**CASE #2010-COA-262 (WD)**

**To approve a Certificate of Appropriateness to:**

**Proposed stairwell addition massing  
(note: roof hatch would be removed and deck would sit on top of roofing material)**

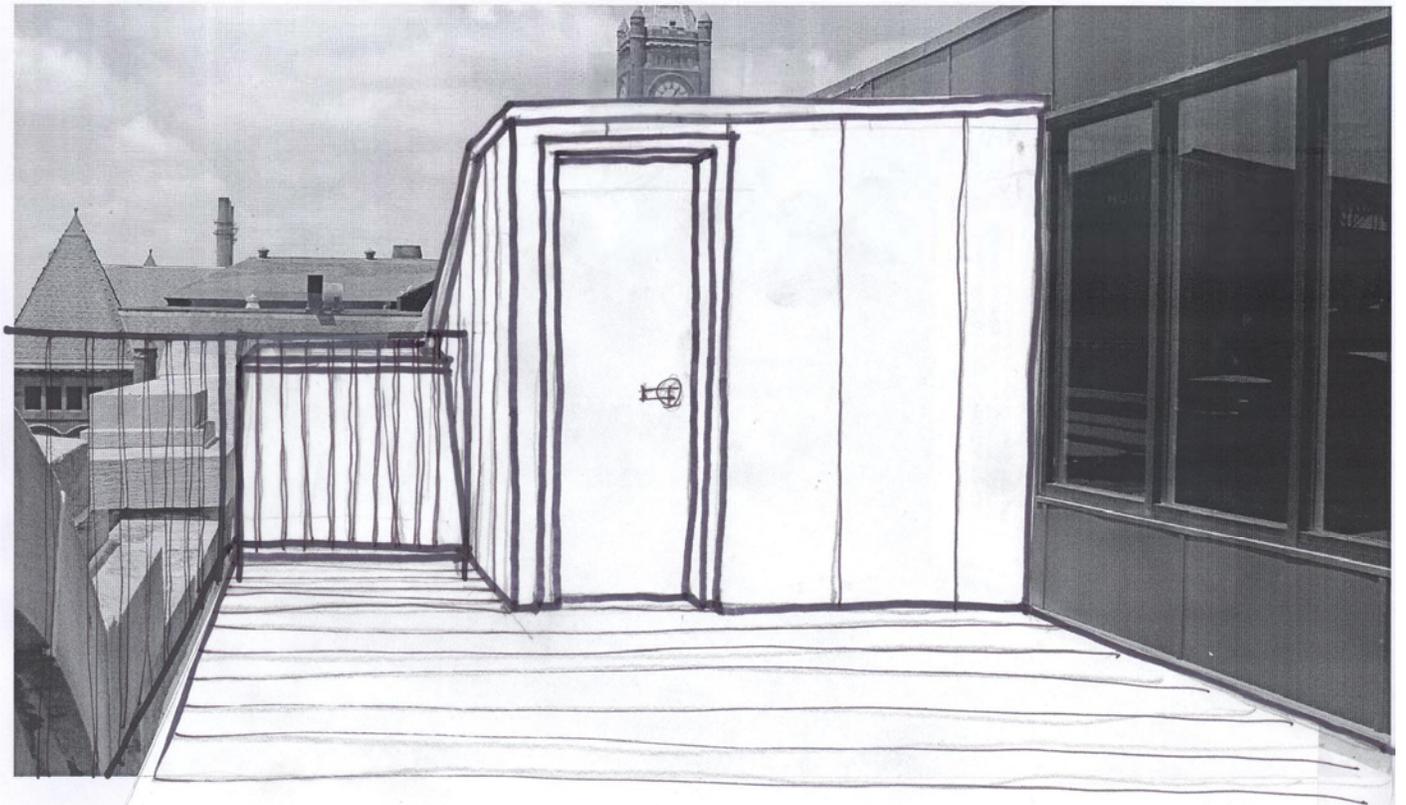
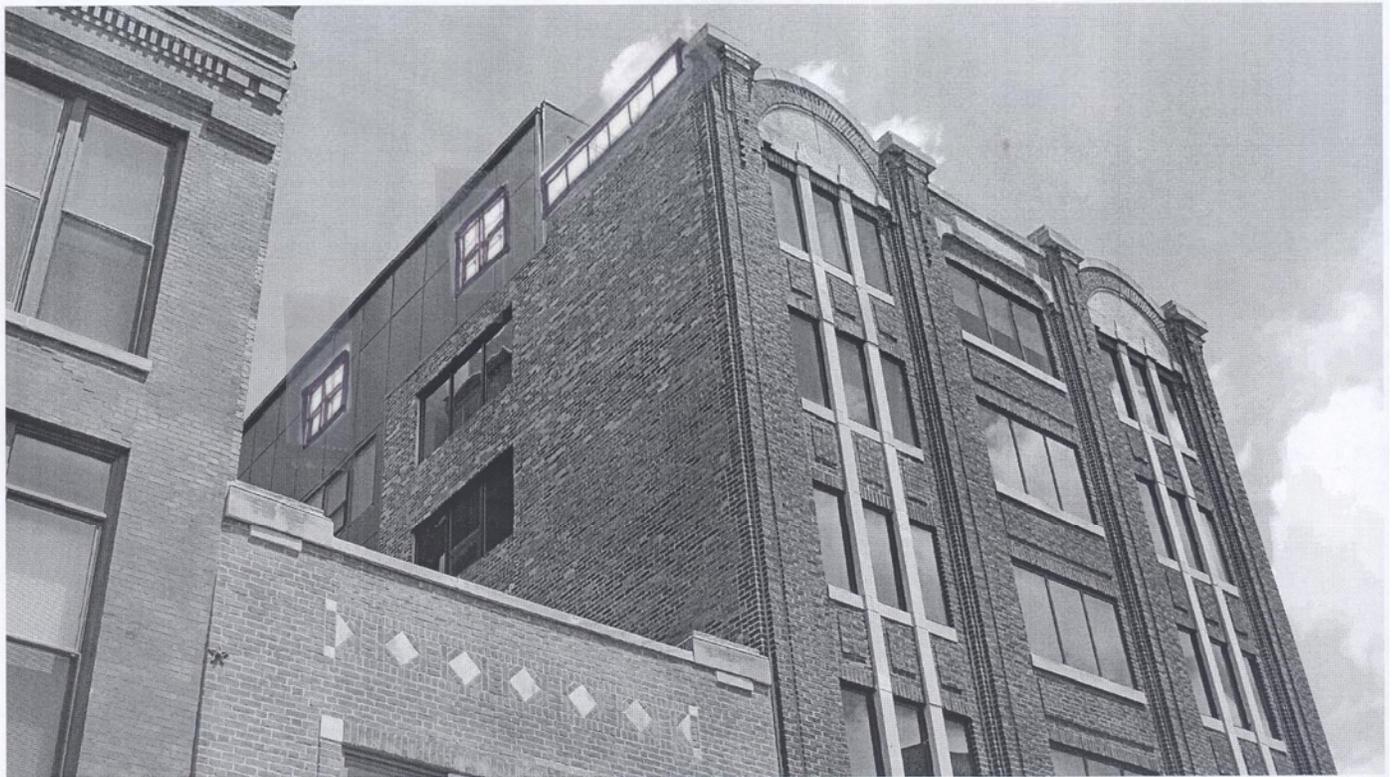
**Stairwell addition:** A new stairwell enclosure addition above the existing southwest fire stair is being proposed to provide a second means of egress from the top floor penthouse unit. This was not part of the original request but has now become an issue since the interior layout of the penthouse space has changed. The existing terra cotta coping along the west wall will need to be removed for the new wall of the addition to be built on top of the existing party wall. This proposal puts the stair bulkhead very close to the Louisiana Street façade wall. At staff's request, the applicant has attempted to minimize the visibility of the addition from the street. The Wholesale District guidelines state that "*design additions to roofs (such as penthouses, storage space, elevator housings, decks and terraces, dormers and skylights) so they are inconspicuous from view from the public right-of-way and do not damage or obscure character-defining features.*"

5. **Deck may not be higher than the lowest portion of the parapet wall.**
6. **Awning shall be of fabric construction on a metal frame. High-sheen finishes are not permitted.**

**Proposed modifications to penthouse exterior (updated)**

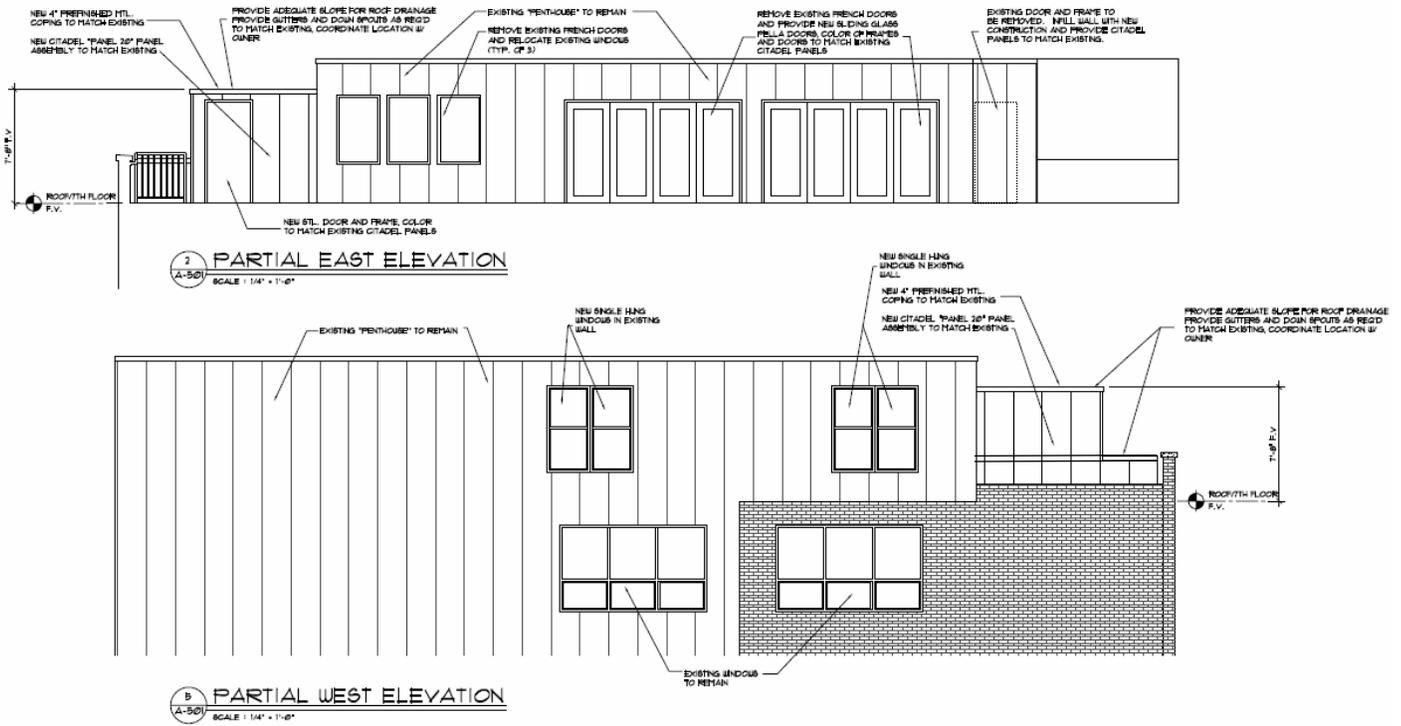
**Penthouse window and door reconfiguration:** Modifications were made to the original request for the penthouse windows and doors. The applicant is requesting for two bays of the east facing wall of the penthouse to receive four sets of metal sliding glass doors opening onto the new roof deck. Existing metal windows from the south side of the penthouse would be relocated to the east bay nearest the southeast corner of the penthouse. The west party wall would receive two sets of metal double hung 'lot line' windows.

Staff finds the request for sliding glass doors to not be inappropriate for the 1987 penthouse addition to this building. Additionally, these doors would not be visible from the street below. Regarding the new 'lot line' windows in the blank sidewall, the Wholesale District rehabilitation guidelines states that "*new openings may be considered in previous 'party walls'. Windows in 'party walls' are considered as temporary since future development may occur on the adjacent site. If new openings are placed in these areas, they should be compatible with the overall design on the building.*" Staff finds the requests for the window and door modifications to the east, west and south sides of the penthouse structure to be reasonable, and therefore recommends approval.

1. **Construction must not commence prior to approval by the IHPC staff of final construction drawings. Approved: \_\_\_\_\_ Date: \_\_\_\_\_**
2. **Final selection of new door and window units shall be approved by IHPC staff prior to purchase or installation. Approved: \_\_\_\_\_ Date: \_\_\_\_\_**

**Proposed parapet railing details**

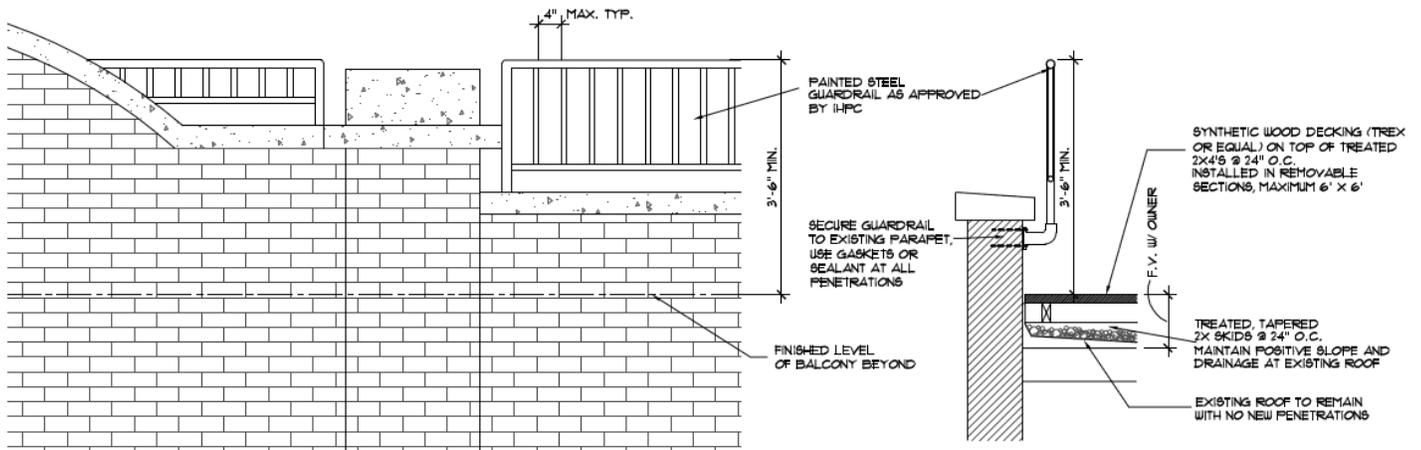
**Railing modification:** A new painted steel guardrail system would be attached to the inner side of the parapet wall. The railing detailing and installation method are similar to the previous request approved at the March 2004 Commission hearing. The applicant is proposing to increase the locations of the railings to provide a more continuous barrier that takes into effect the varying heights of the parapet wall. Because the railing is mounted to the inner side of the parapet walls, staff finds that the railing will be minimally visible from the street. Staff's recommendation remains the same to approve this element of the request.

3. **New exterior metal panels shall match existing in finish, configuration, and method of construction.**
4. **Railing supports and hardware must be installed using methods which cause as little damage as possible to the exterior walls. Fasteners at masonry locations should be installed in the mortar joints. Do not drill into or otherwise damage masonry (brick, block, structural tile, etc.).**

Proposed awning approved in March 2004

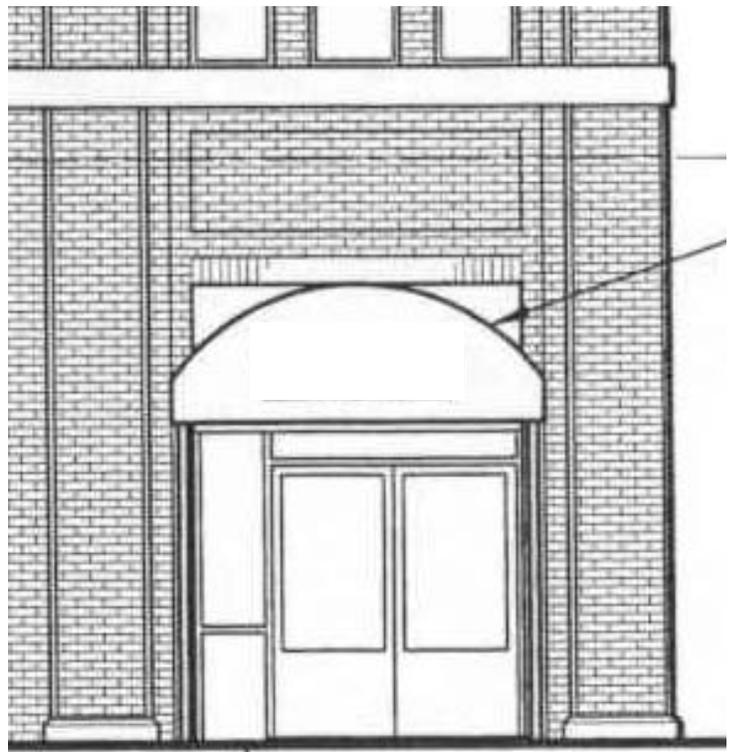
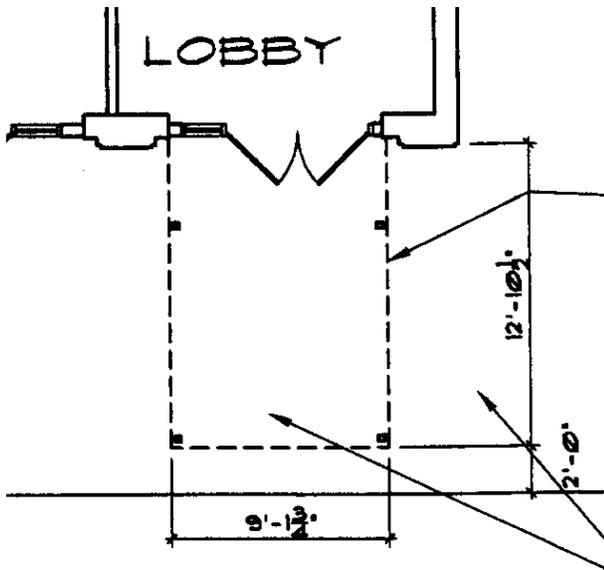
**Ground floor entry awning:** The applicant is asking to install a fabric covered vaulted canopy-type awning similar to the one that was approved as a part of the previous request above the northern-most entry doors along the Meridian Street side of the building. The applicant is not including any signage on the awning at this time. Staff's recommendation is unchanged regarding this part of the request.

7. **Signage is not permitted by this certificate. Any text, numerals, logos, or other signage will require a separate certificate.**
8. **No changes to the proposed design, location, configuration, or method of installation are permitted without prior consultation with IHPC staff. Notify IHPC staff prior to making unexpected repairs.**
